ADDENDUM NO. 1

**Administration Building Renovation Re-bid
Compton Community College District**

tBP Project. No. 20987.00

tBP/ARCHITECTURE

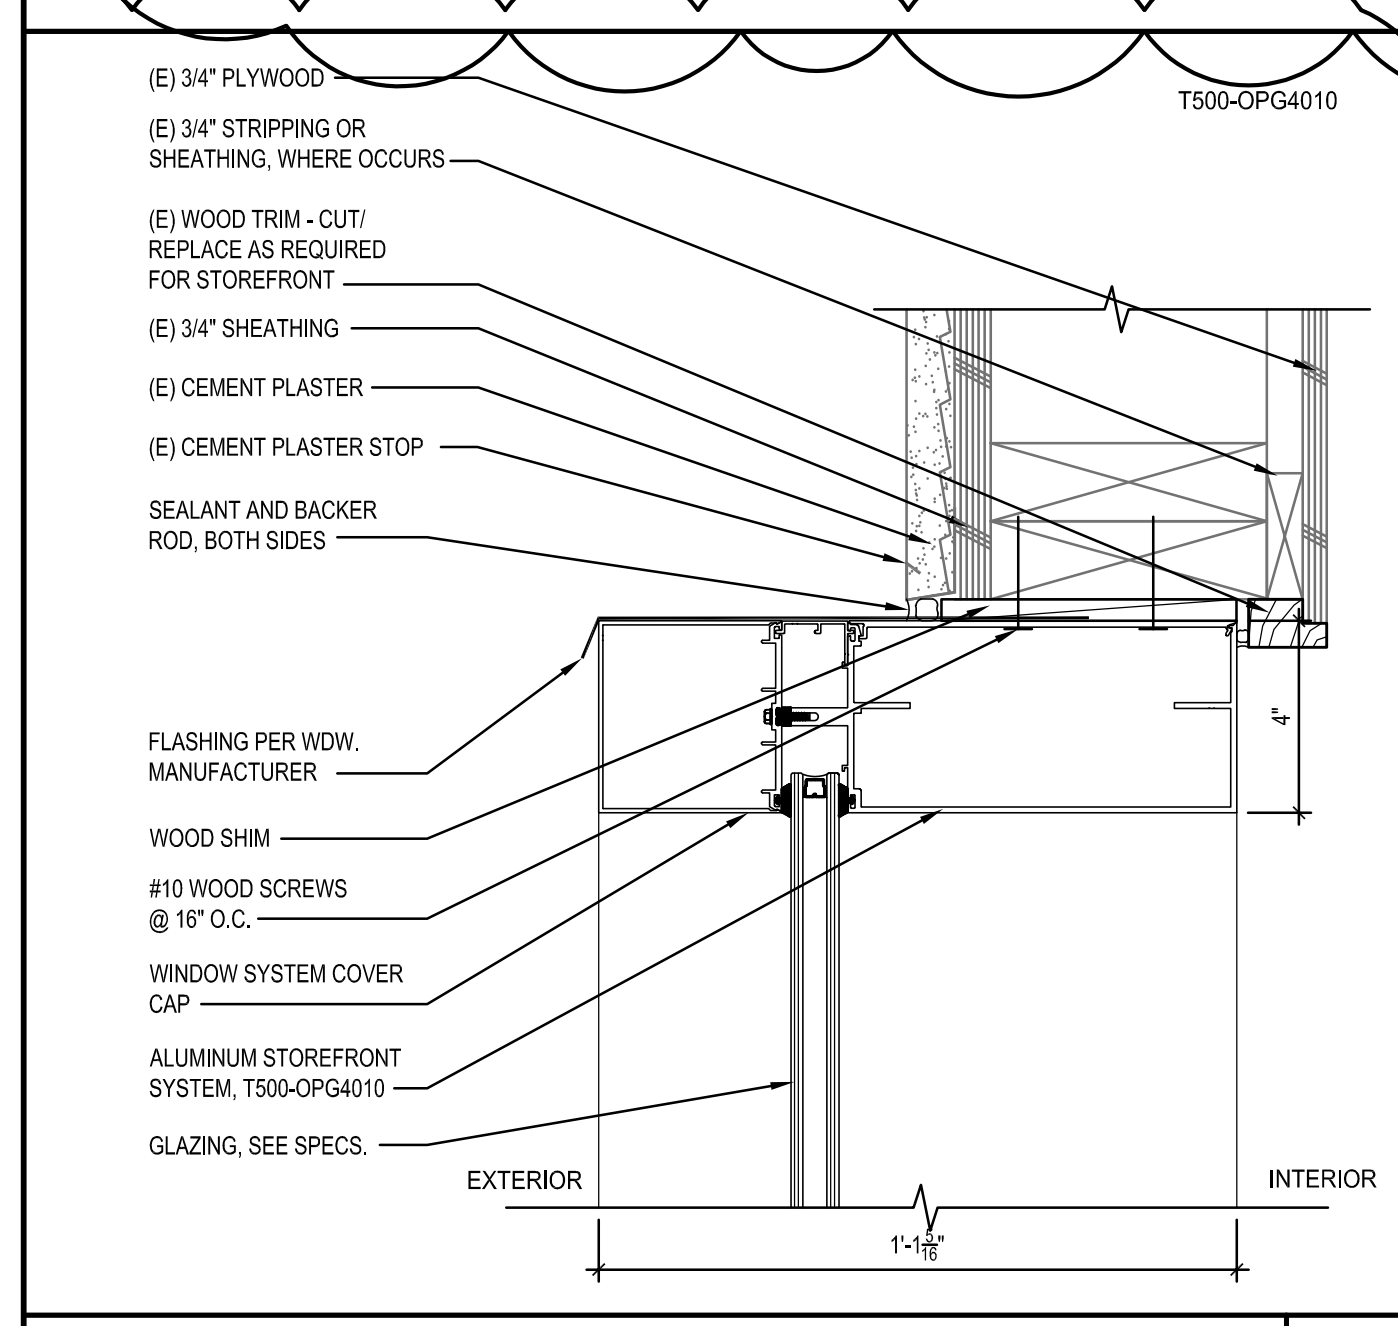
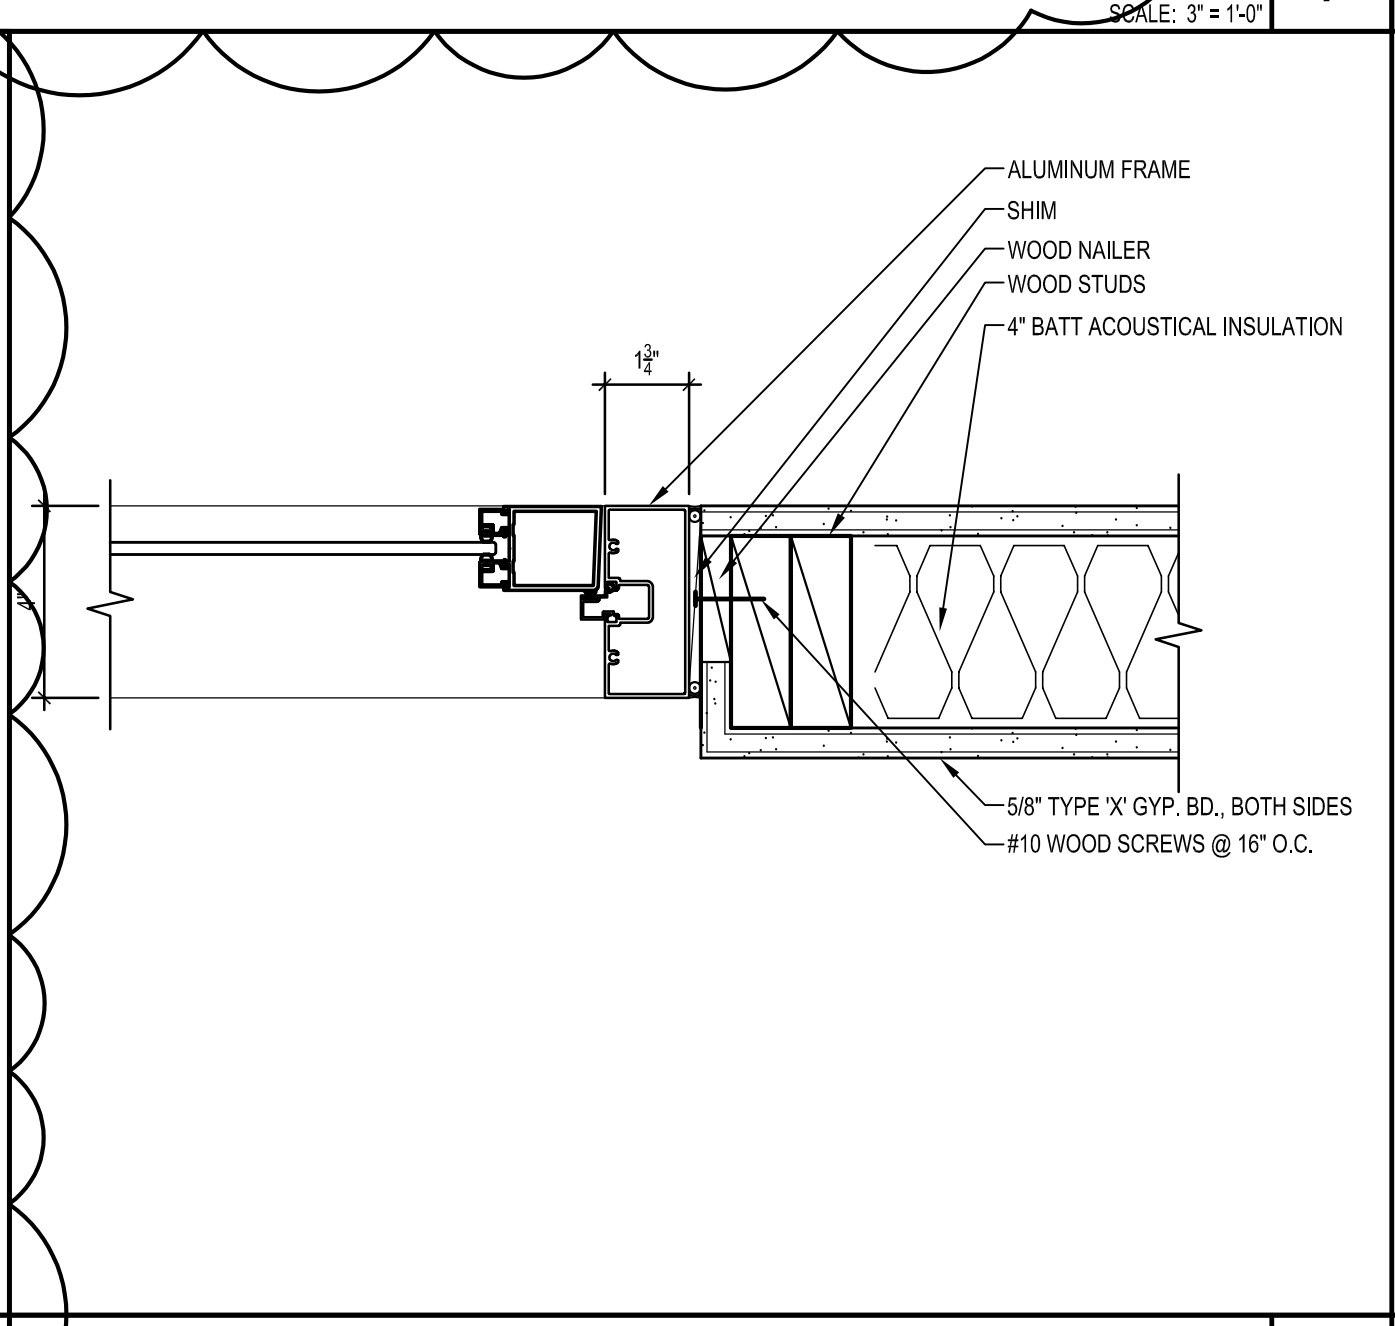
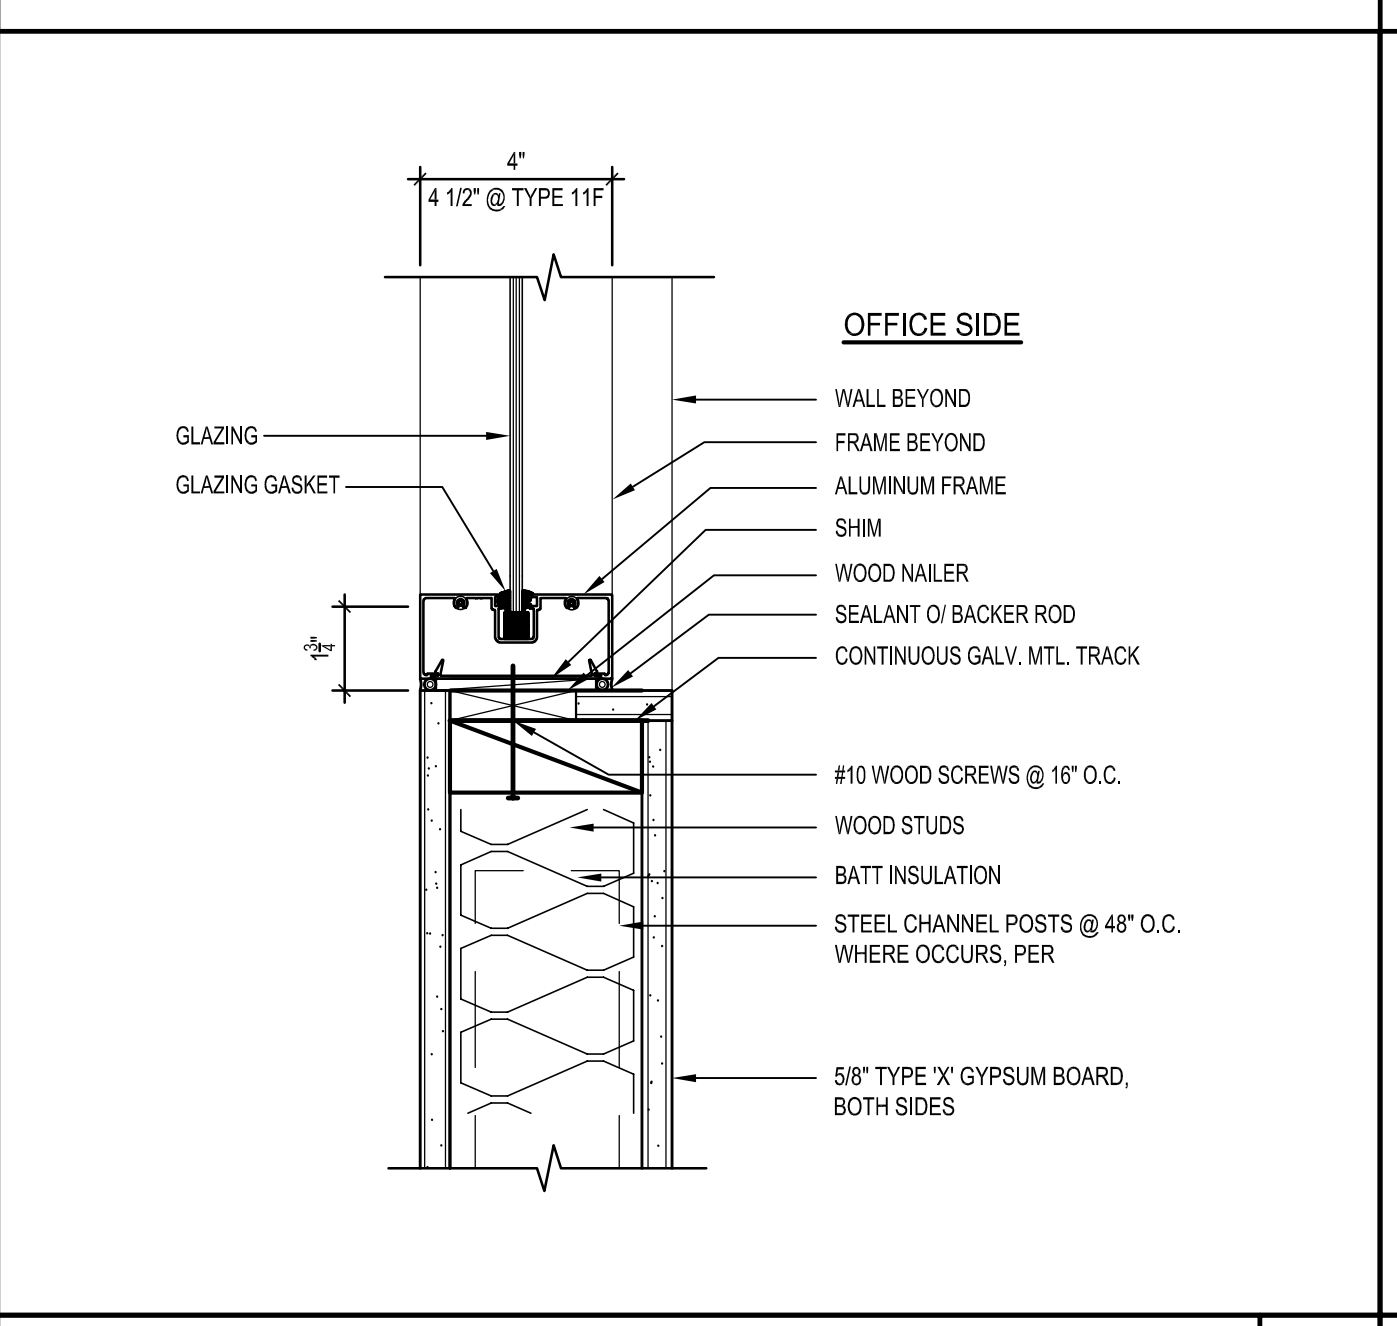
15. **Revised SHEET 8.03 STOREFRONT DETAILS**
- a. Added details for added window AL-21 Window details #s 7, 11 and 16.
See attached revised Full size sheet identifying revisions included as part of this addendum.
